STAFF ANALYSIS

Case No.: Z-21-1244535 **Agenda #:** N. 9

Location/Address: 2490 North Druid Hills Road, and 1600 and 1613 Mount Mariah Road, Atlanta **Commission District:** 2 **Super District:** 6

Request: Rezone properties from RSM (Small Lot Residential Mix) and R-85 (Residential-Medium Lot-85) to HR-2 (High Density Residential-2) to allow multifamily apartments.

SHEET NO. Z1

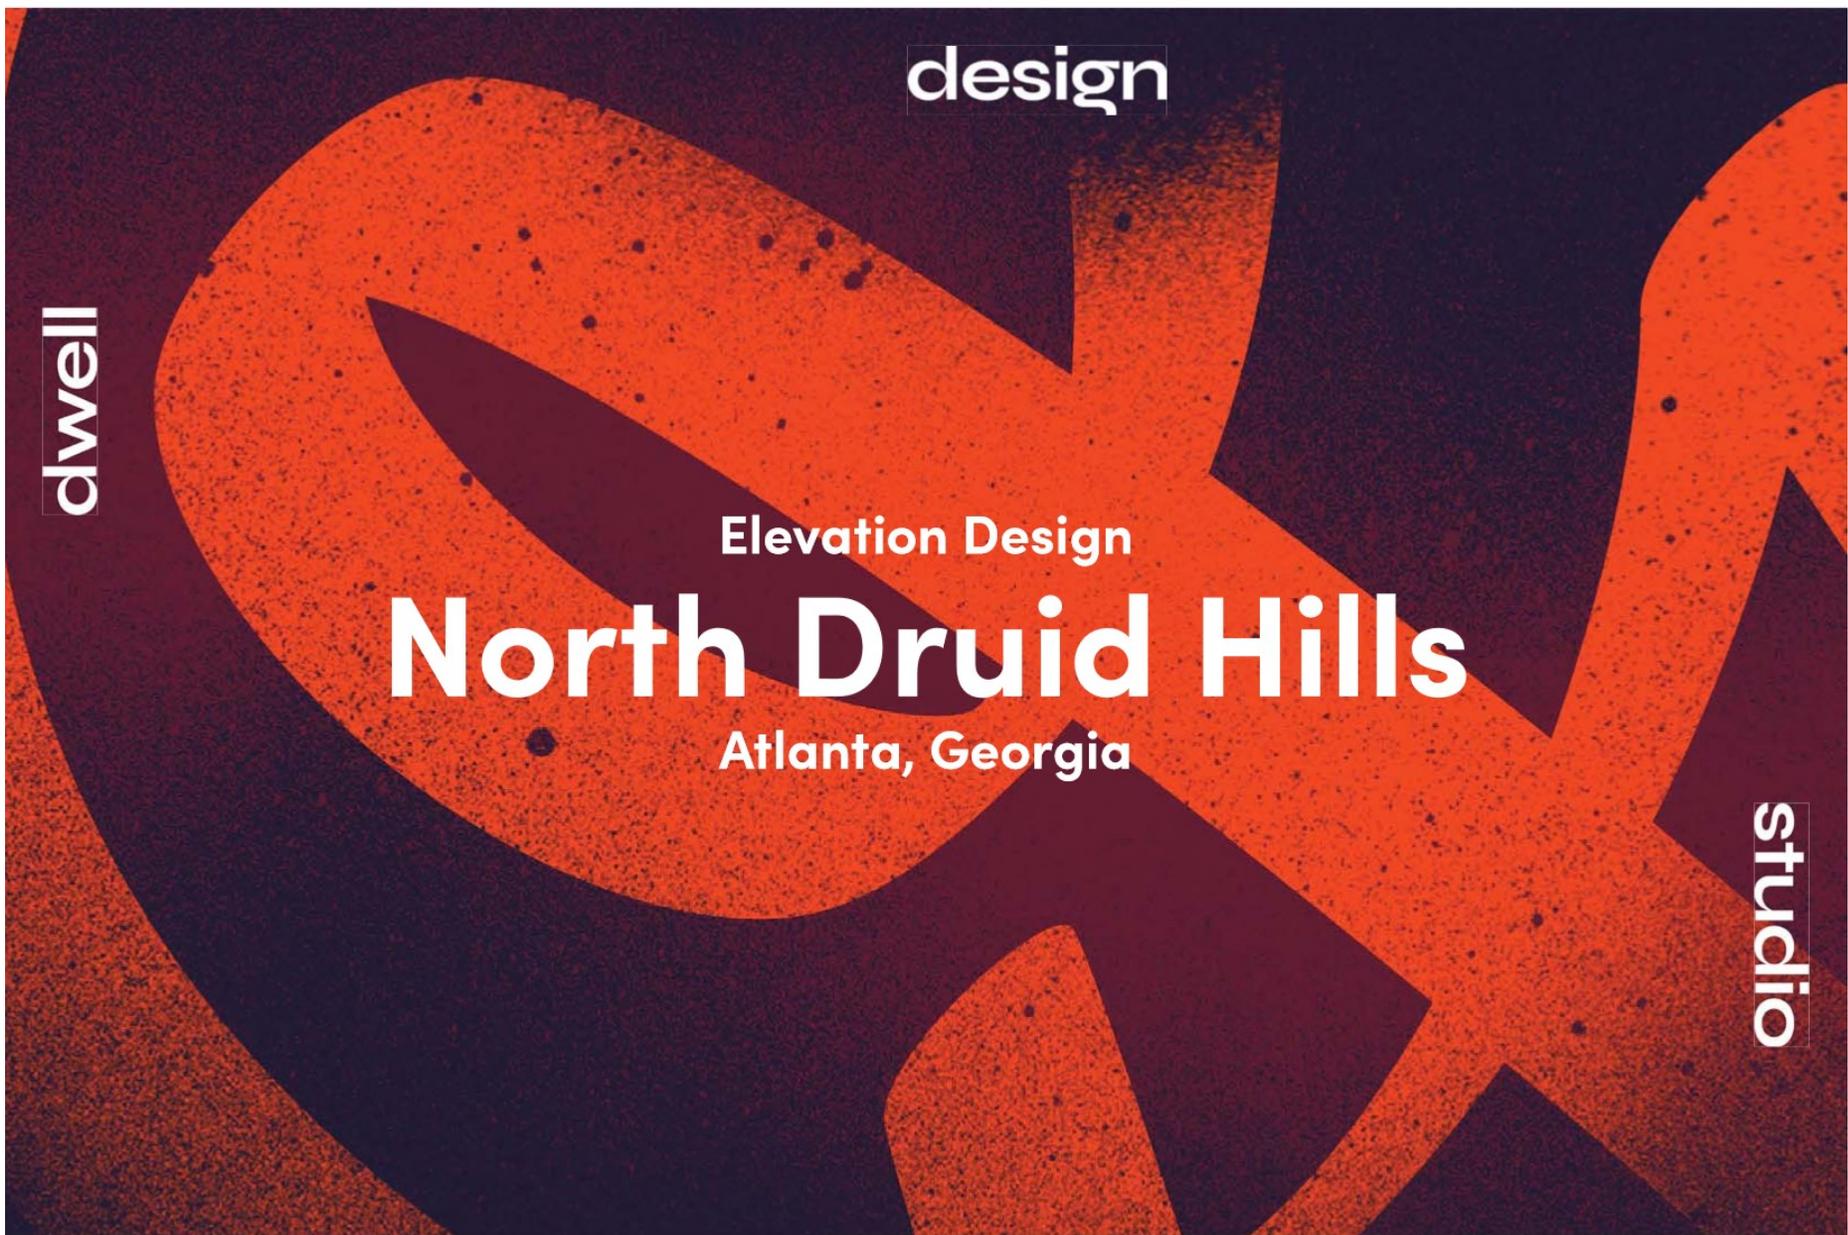
STREETSCAPING - N. DRUID HILLS		Min. 4-ft. bike lane as per Section 27-14.190 of the DeKalb County Code	No bike lane shown on site plans.	A Planning Commission variance will be necessary.
MIN. STREETSCAPE DIMENSIONS – MT. MORIAH		6-ft. landscape strip and 5-ft. sidewalk on each side, light poles 100 ft. on center and street trees 30 ft. on center Landscape strip may be split to avoid interference with above-ground utilities.	3-ft. landscape strip, 6-ft. sidewalk, 3-ft. landscape strip; street trees 40' on center. Note: there are no existing above-ground utilities along Mt. Moriah Rd.	Variances will be necessary.

N9. This development requires a traffic study (337 units) be presented to identify required improvements prior to zoning. I recommend deferral until a traffic study is submitted so that we can incorporate the result of the traffic study into the zoning conditions. Traffic study should address requirements for left turning lanes and right turn lane on North Druid Hills at the Mount Moriah Road and the need for a potential traffic signal. Please confirm the existing right of way on Mount Moriah Road. The county records show a 60 foot right of way and it appears that the development is encroaching on the right of way. The study should also address the lanes needed to accommodate the traffic exiting Mount Moriah Rd at the intersection. Direct pedestrian access is to be provided from the public sidewalks to the proposed development. North Druid Hills Road is classified as a major arterial. Please note the infrastructure requirements in Chapter 5 of the Zoning Code and Chapter 14-190 of the Land Development Code. A right of way dedication of 50 from centerline or such that all public infrastructure

(sidewalks/streetlights) are within right of way, whichever greater. Required at a minimum: 10- foot landscape strip, 6-foot sidewalk, bike lanes or multiuse path, streetlights. All access points must meet minimum intersection and stopping sight distance requirements per AASHTO Greenbook for the posted speed limit and presented (signed and sealed by a professional engineer)with the land development permit documents. Mount Moriah Road is classified as a local road. Please note the infrastructure requirements in Chapter 5 of the Zoning Code and Chapter 14-190 of the Land Development Code. A right of way dedication of 27.5 feet from centerline or such that all public infrastructure (sidewalks/streetlights) are within right of way, whichever greater. Required at a minimum: 6- foot landscape strip, 5-foot sidewalk, streetlights. Mount Moriah Road must be brought up to minimum county standards to include at least 22 feet of pavement along entire property frontage. All access points must meet minimum intersection and stopping sight distance requirements per AASHTO Greenbook for the posted speed limit and presented (signed and sealed by a professional engineer)with the land development permit documents.

Multimodal Corridor Proposed for N. Druid Hills Road, including section of road on which the subject property fronts.

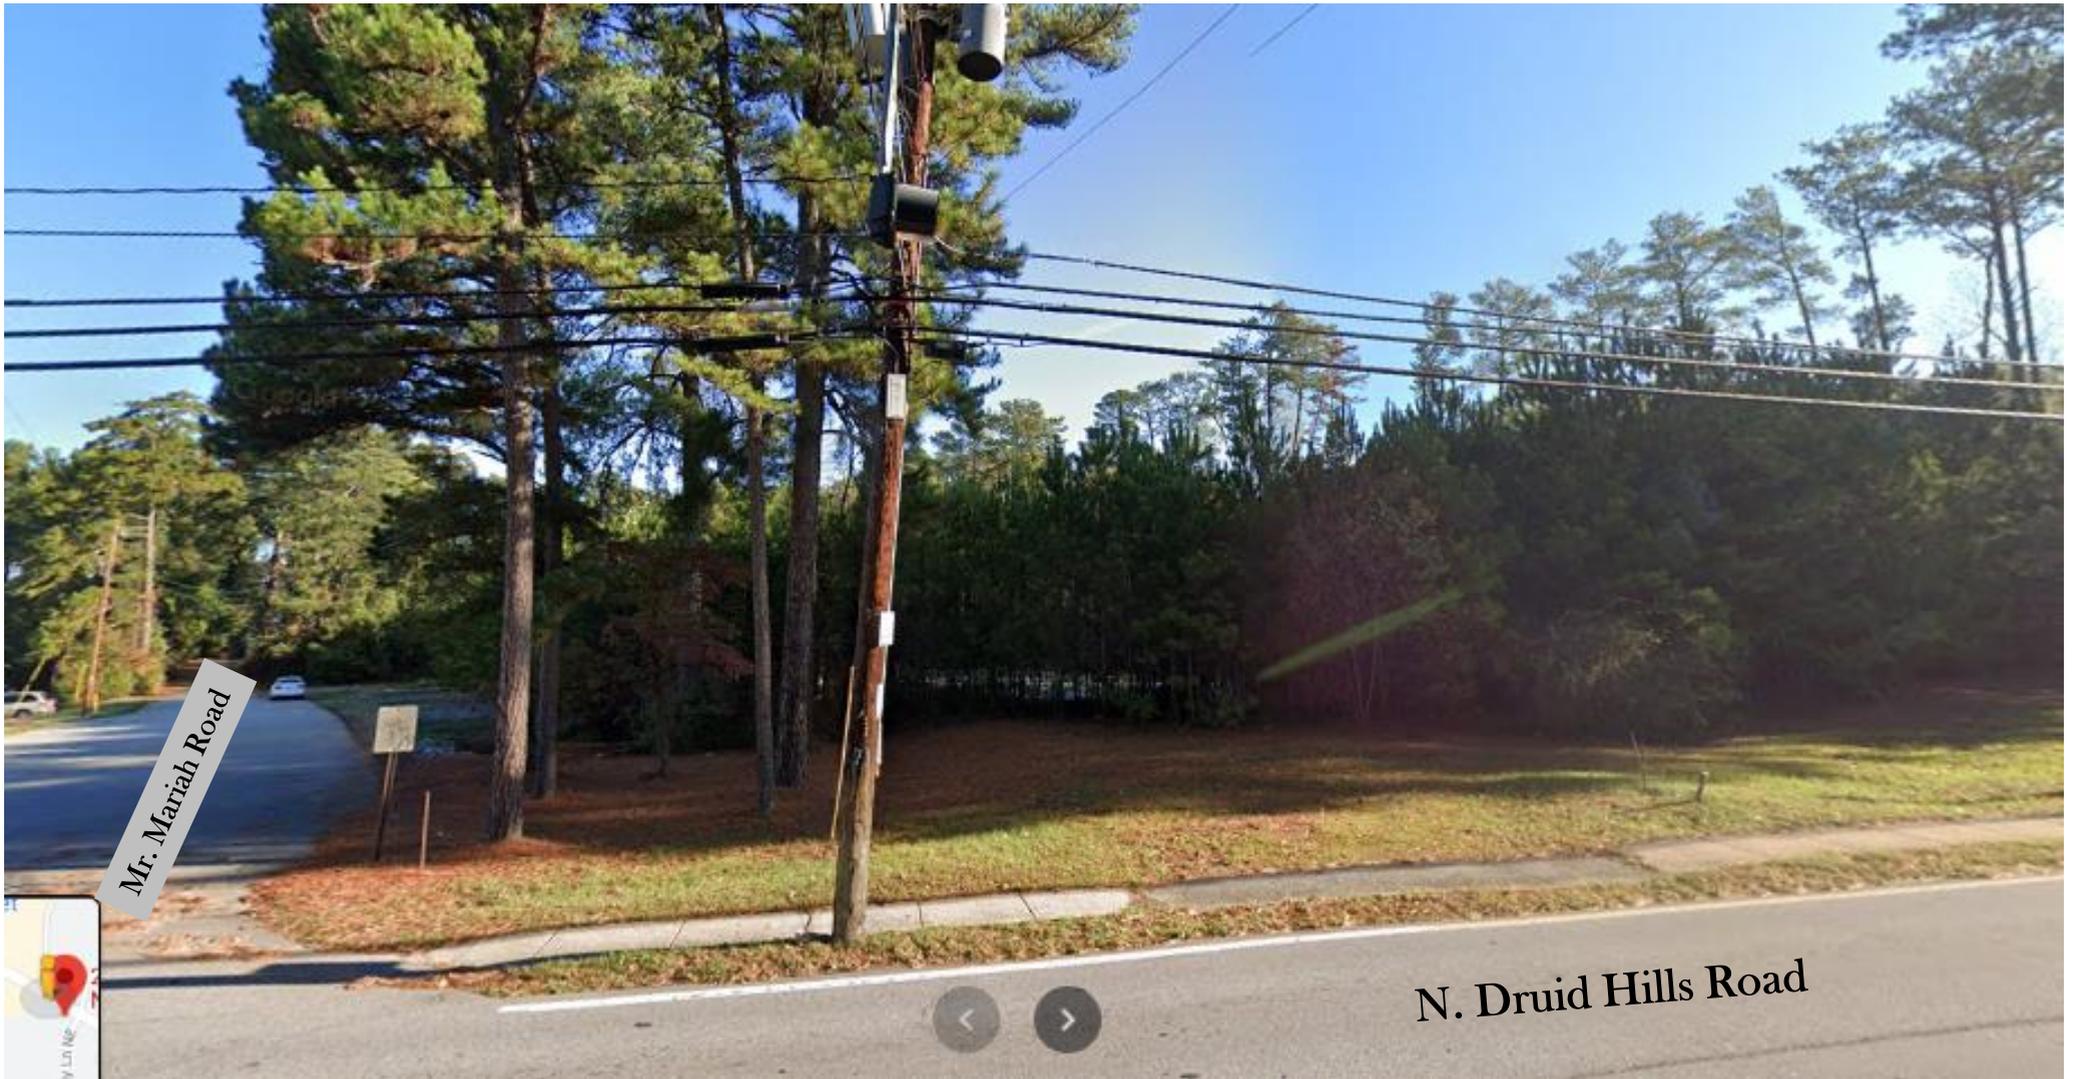
78 (Scott Boulevard/Lawrenceville Highway) to Buford Highway, which includes the section of North Druid Hills Road on which the property fronts, be converted to a multimodal highway. The term “multimodal” means inclusion of bike lanes, pedestrian facilities, and a median (either landscaped or a center turn lane). In addition, the DeKalb County Transit Master Plan (TMP) includes a planned Arterial Rapid Transit (ART) route along North Druid Hills Road. It is not clear how the proposal under consideration will affect design of the multimodal corridor or the ART route. The proposal provides pedestrian facilities but does not allow for a bike lane along the property frontage.
